**Freightliner
Service Bulletin**

Description of Revisions This bulletin replaces the version dated 09/12/2017. Information is added about engine brake and cruise control telltales.

ICU3 to ICU3S Replacement Guidelines

Fig. 5, ICU3 Optional Telltale Locations

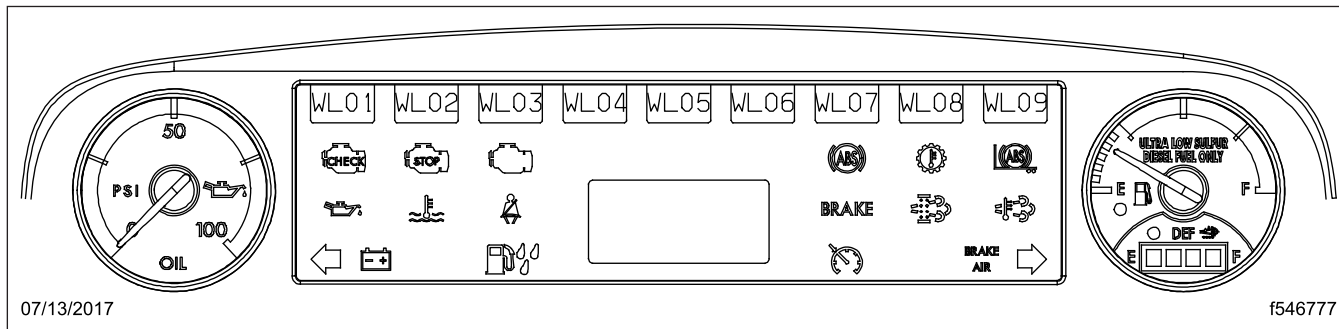
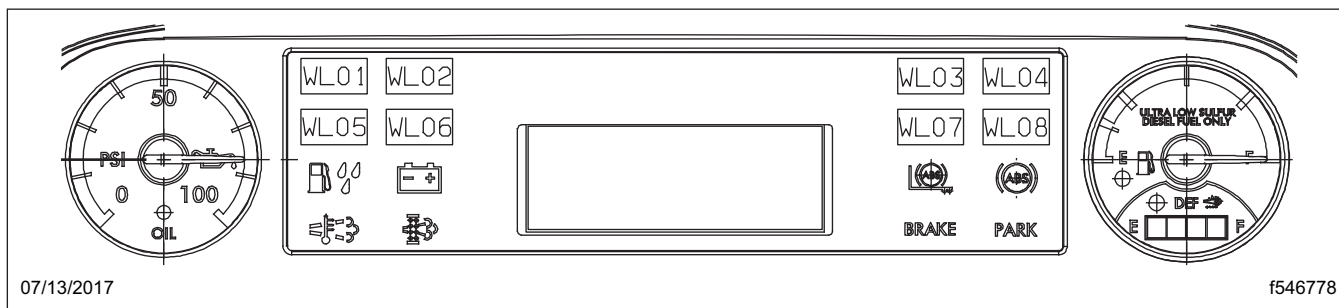
Refer to [Fig. 5](#) and [Fig. 6](#) to correlate the ICU3 telltale locations with the ICU3S locations. The ICU3 has 9 optional telltales, numbered 1 through 9 from left to right. The ICU3S has 8 optional telltales, 1 through 4 on the top row, and 5 through 8 on the second row.
